V2500-A1/A5 NACELLE SERVICE BULLETIN

This document transmits the Initial Issue of Service Bulletin NV2500-24-0014

V2500-NAC-24-0014

NACELLE - POWERPLANT - IDG COOLING TUBES - 'O' RING SEALS - REPLACEMENT OF

Replacement of IDG Cooling Tube Seals - L/H and R/H Figure 1

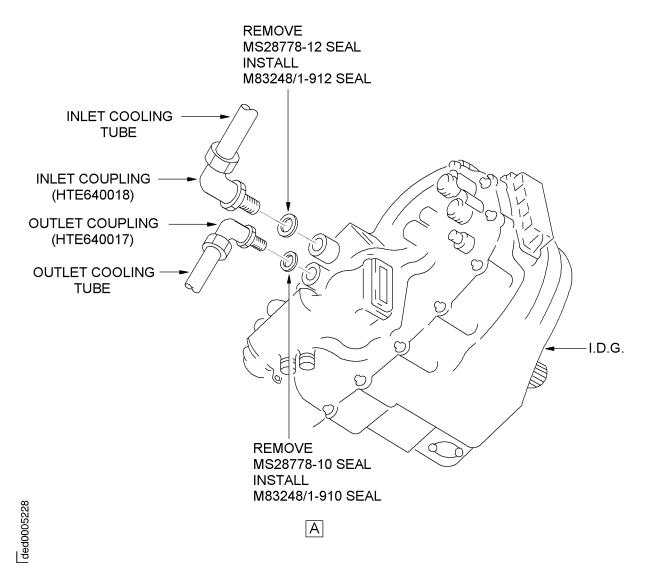
- (1) The change introduced by this Service Bulletin is as follows:
 - (a) The packing seals at the IDG inlet and outlet cooling tubes are removed and replaced with new seals.

- B. Modification Instructions
 - (1) Cut and remove the lockwire from the IDG 640018 inlet and the HTE 640017 outlet couplings on the IDG. Refer to Figure 1.

- (2) Remove and retain the circlips and disconnect the inlet and outlet couplings from the IDG.
 - (3) Remove and discard the MS28778-10 and MS28778-12 packing seals.

- (4) Lubricate the new M83248/1-912 packing seal with clean system oil (CoMat 10-077) and install to the HTE 640018 inlet coupling. Connect the HTE 640018 inlet coupling.

- (5) Torque the HTE 640018 inlet coupling to 550-600 LBFIN (62-68 NM) and install the circlip removed in step 2.B.(2). Refer to the Standard Practices/Processes Manual, Task 70-41-02-410-501.

- (6) Lubricate the new M83248/1-910 packing seal with clean system oil (CoMat 10-077) and install to the HTE 640017 outlet coupling. Connect the HTE 640017 outlet coupling.

- (7) Torque the HTE640017 outlet coupling to 380-405 LBFIN (43-48 NM) and install the circlip removed in step 2.B.(2). Refer to the Standard Practices/Processes Manual, Task 70-41-02-410-501.

- (8) Safety the inlet and outlet couplings with lockwire (CoMat O2-138).
- C. Post-requisite Instructions
 - (1) Replenish the Integrated Drive Generator with clean system oil (CoMat 10-077). Refer to the A320/V2500 Aircraft Maintenance Manual, Task 12-13-24-612-011.
